RCS Add-On: Purpose and Feasibility) of Adding Treatments to RCS Study Design

Prepared by [The RCS Add-on Work Group](#) Doug Martin, Joe Murray, [John Heimburg](#), [Harry Bell](#), [Mark Meleasom](#), [Patrick Lizon](#)

Date [November 29, 2021](#) [January 3, 2022](#) [March 2, 2022](#)

Figure 1. RCS study design showing site layout and the three harvest sequences (from Figure 1; Volke 2020).

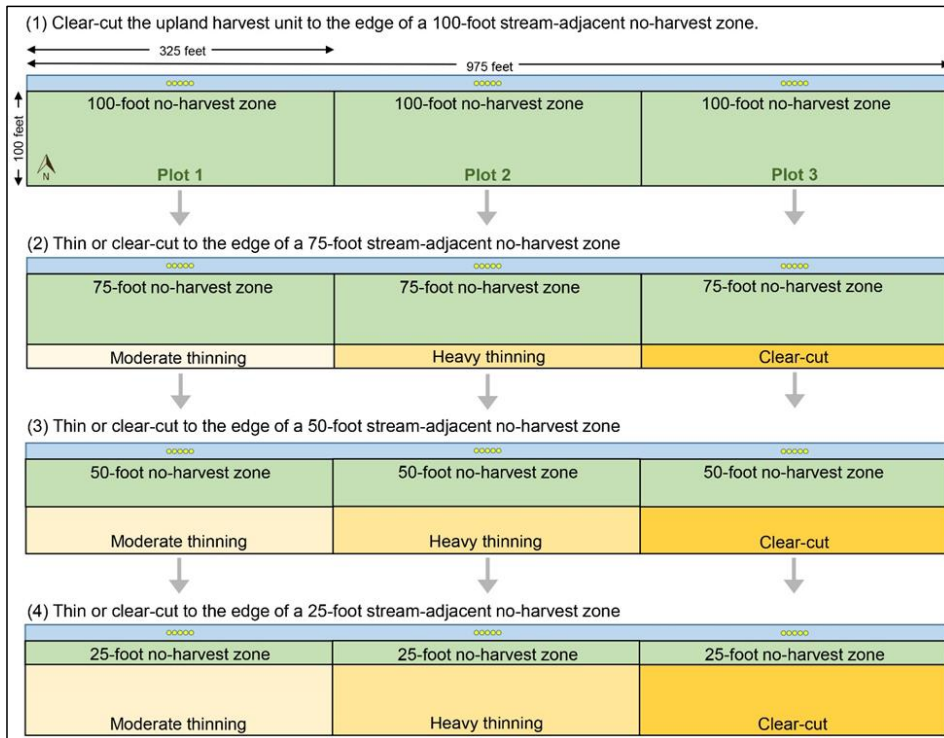
The existing RCS study treatment and plot scheme with Add-On treatments are shown in Figure 1. The Add-On includes the following:
